Land Rover North America, Inc.  
Land Rover Canada

# SERVICE BULLETIN

Bulletin: **SRE05-09**  
Section: **Recall**  
Date: **09 September 2005**  
Model: **LR3**

**Subject: B016 Safety Recall - Quarantined Vehicles  
Fuel Tank Replacement Prior to Launch of Customer Notification**

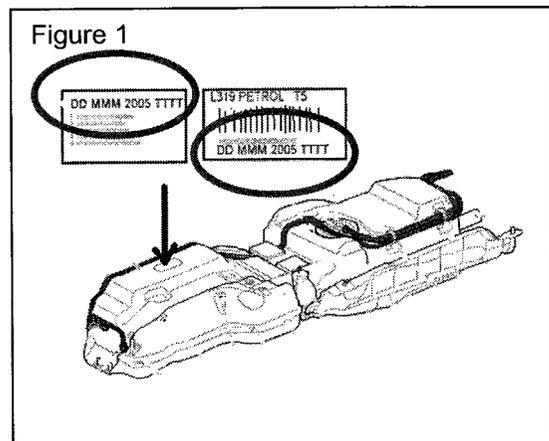
All fuel tanks must be inspected prior to installation in any affected vehicle to ensure that the manufacturing date is **AFTER 01 MAY 2005**. The date is located on labels on the top of the tank assembly (Figure 1) and follows standard European date format:

**01 MAY 2005 0915**  
Day Month Year Time
